SERVICE BULLETIN

Removal of MEWP Return line Ball Valve (Option Z87)

Doc. No: SRB001					
Rev No.:	Date:	Author:	Description:		
-	13/10/2023	MDanks	Original Issue

Figure 1 - Removing Cable Ties and Hose Clamp

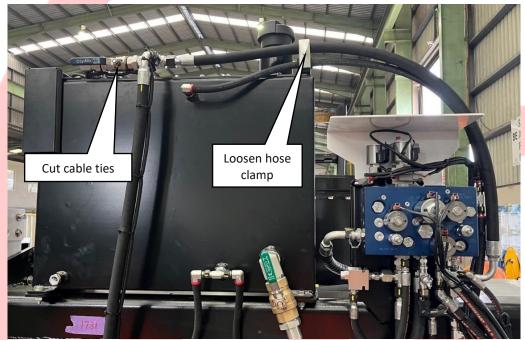
- 1. Discharge all hydraulic power (turn truck ignition off)
- 2. Cut cable ties to free the electrical cable and loosen the hose clamp. See Figure 1 below.

Figure 2 - Removing Ball Valve

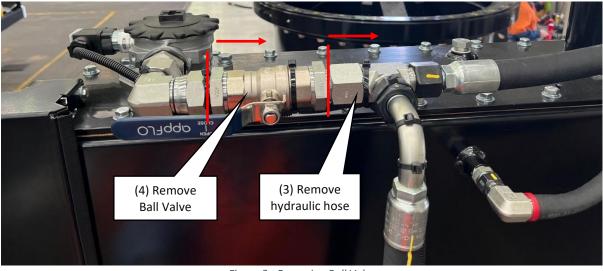
- 3. Remove the hydraulic hose from the ball valve. NOTE: Some residual hydraulic oil may be present.
- 4. Remove the ball valve from elbow fitting. See Figure 2 below.
